**AGENCY:** Planning Commission

## AGENDA ITEM SUMMARY REPORT

**APPLICATION NO.:** Design Review 3-24 (DR 3-24); Variance 1-24 (VAR 1-24); Coastal Development Permit (CDP 3-23); Sign Permit (SP 2-24)

**LOCATION:** 105 South Main Street. This property is in the Coastal Zone.

Figure 2: Zoning map illustrating that Heavy Industrial zoning is anomalous in this location.

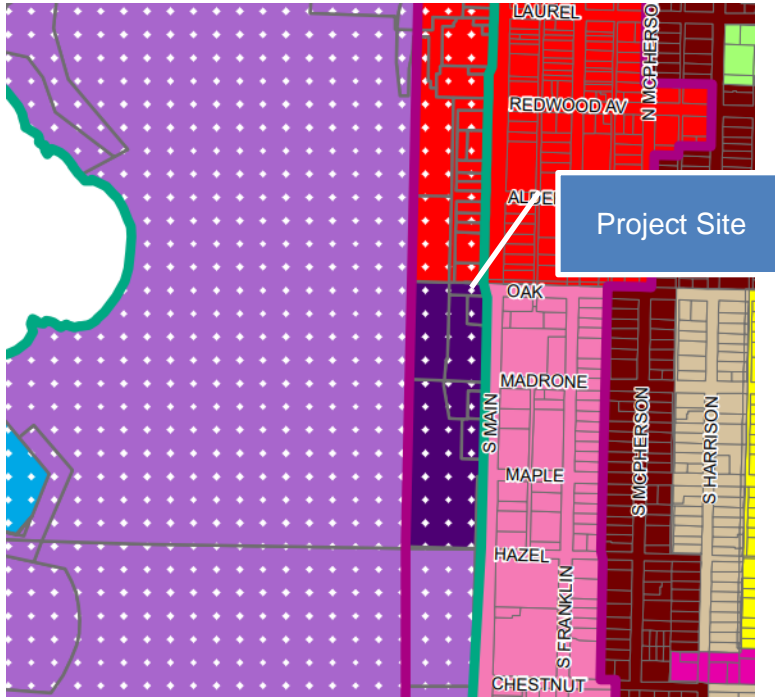
This property has special circumstances regarding its location. The project site is part of a small group of properties that are located within a Heavy Industrial zoning district within the commercial core of Fort Bragg. This zoning appears to be a legacy related to the operation of the Georgia-Pacific lumber mill, see figure 1 below. Certainly, the City would likely not welcome heavy industrial businesses in this location and the 30' setback is intended to reduce the impact of heavy industrial businesses on Main Street and the commercial corridor. In fact, none of the businesses located within this zoning district are heavy industrial uses. All businesses are retail oriented and include: a

visitor information center, an accountant, a building materials and hardware store and this gas station. Thus, The Planning Commission can fund that “there are special circumstances applicable to the property, including ....location and surroundings.”

Figure 6 South Elevation adjacent to Mendo Mill & North Elevation facing Oak St.

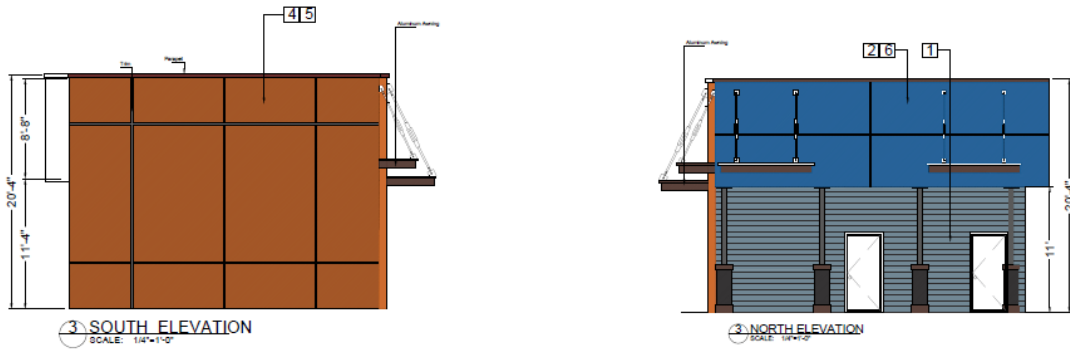
This finding can be made. The proposed exterior remodel would consist of an architectural look the combines false fronts, awnings, changes of materials, and changes of plane. The overall look is modern with a historic nod. The new structure would have better design quality than the existing building and would provide an upgrade to the architectural character of the buildings in the immediate site surroundings.

Figure 12: Site Plan

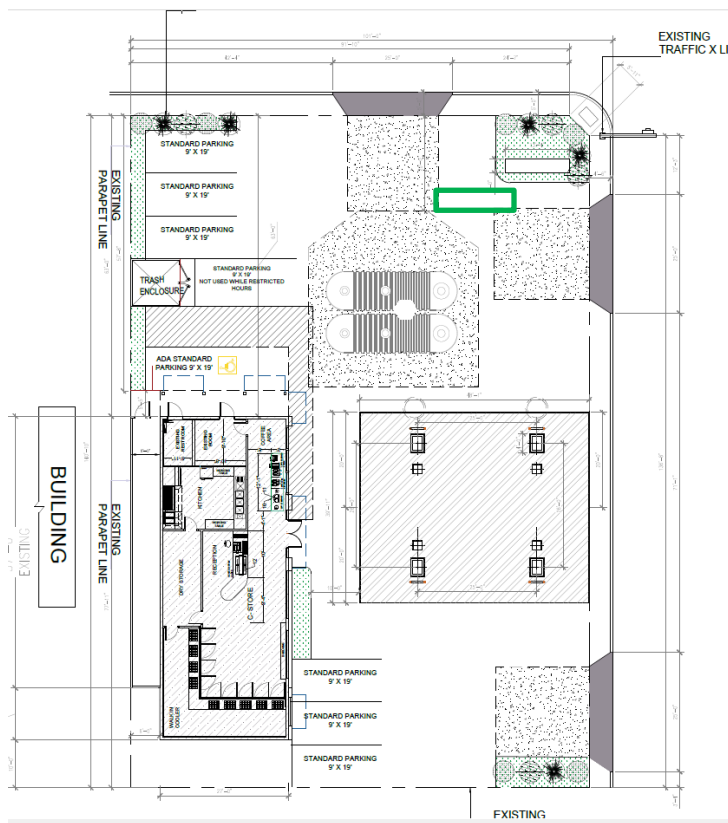
**Parking.** Table 3-7 of the CLUDC stipulates the quantity of parking spaces required for each land use. Service Stations require “one space for each 300 square feet of floor area, plus three spaces for each storage bay.” The proposed 1,809 SF convenience store therefore requires six parking spaces. The CLUDC also requires that one of the six spaces be an ADA space. The initial site plan preserved the existing five parking spaces at the service station, which was inconsistent with CLUDC requirements. However, the applicant resubmitted the site plan with six regular parking spaces and one ADA space. The Code also requires a five-foot landscaping strip between the parking spaces and the building. Therefore, MJC recommends Special Condition 1.

This finding can be made. The re-submitted site plan includes seven parking spaces at the service station which are located conveniently to the convenience store and bathrooms. No changes to circulation or access are proposed and the circulation program is appropriate for a corner gas station.

**Special Condition 1:** the applicant shall install a five-foot wide landscaping strip between the convenience store and the three parking spaces on the south side of the project and a five-foot wide landscaping strip between the parking stalls north of the store and the property line, prior to final of the building permit.
